NL-19-0698

Edwin I. Hatch Nuclear Plant – Units 1 and 2
License Amendment Request to Correct Non-Conservative Technical Specification
Allowable Values for the Condensate Storage Tank Low Level Transfer Function
SNC Response to NRC Request for Additional Information

SNC Response to NRC Request for Additional Information (RAIs)

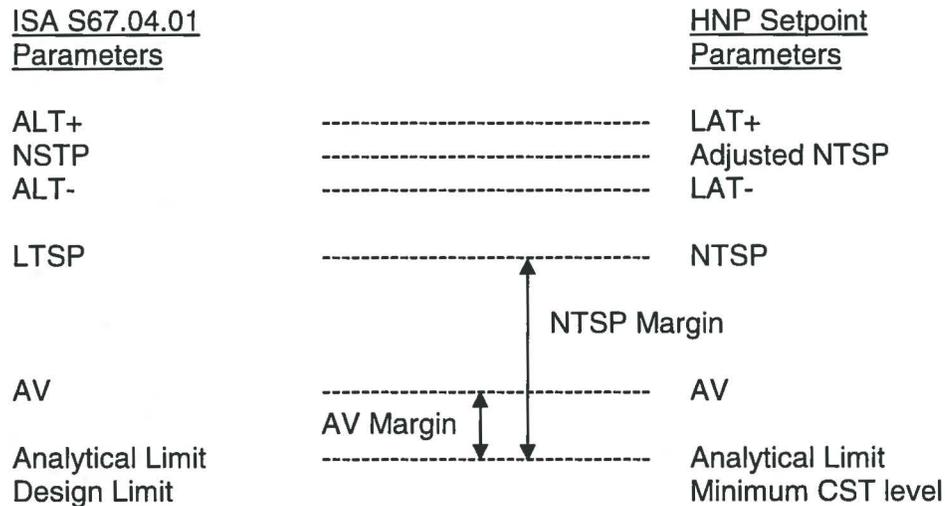
Setpoint Calculation Methodology: Please provide documentation (including sample calculations) of the methodology used for establishing the limiting setpoint (or nominal setpoint (NSP)) and the limiting acceptable values for the As-Found and As-Left setpoints as measured in periodic surveillance testing as described below. Indicate the related Analytical Limits (AL) and other limiting design values (and the sources of these values) for each setpoint.

Note: The licensee can provide a setpoint methodology summary and calculation summary in lieu of a sample calculation, which must start from AL and address total loop uncertainty (TLU), nominal trip setpoint (NTSP), actual trip setpoint if different from NTSP, AV and margins.

For variables that decrease to the setpoint, the AV and NTSP are obtained by adding the margin from the analytical limit. Thus:

- $\text{AV} = \text{AL} + \text{AV Margin}$ (for decreasing setpoint).
- $\text{NTSP} = \text{AL} + \text{NTSP Margin}$ (for decreasing setpoint).

The following provides a simplified visual presentation of the above terms similar to the guidance of RG 1.105 (Reference 4):
